Access Compliance Report Public Rights-of-Way (Curb Ramps)

Main Street: ESPLANADE_AVE		Cross Street: FAIRHAVEN_AVE		Location:	SW
ADA ID: RPAT211111105132		Ramp Type: Type 1 - Perpendicular Diagonal Initial Pass/Fail: Fail		Overall Compliance: No	Severity Score: 16
Codes/Mitigation Info/Possible Solution			Field Measurements/Component Compliance

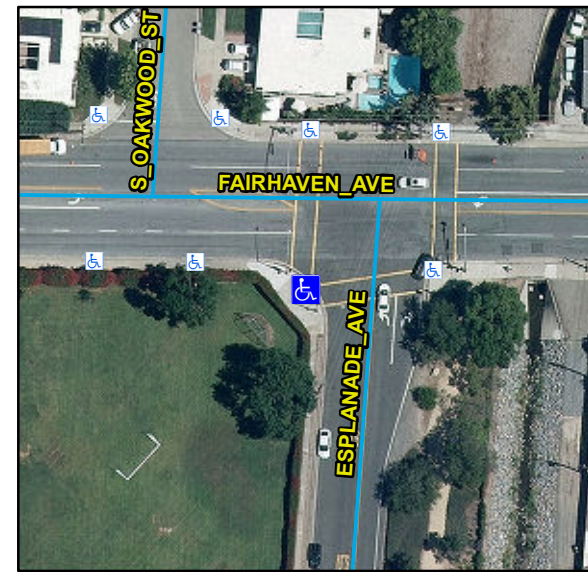
R204.3, R304.2.2, STD 1115

Remove & Replace Curb Ramp With Two New Directional Ramps or Equivalent.
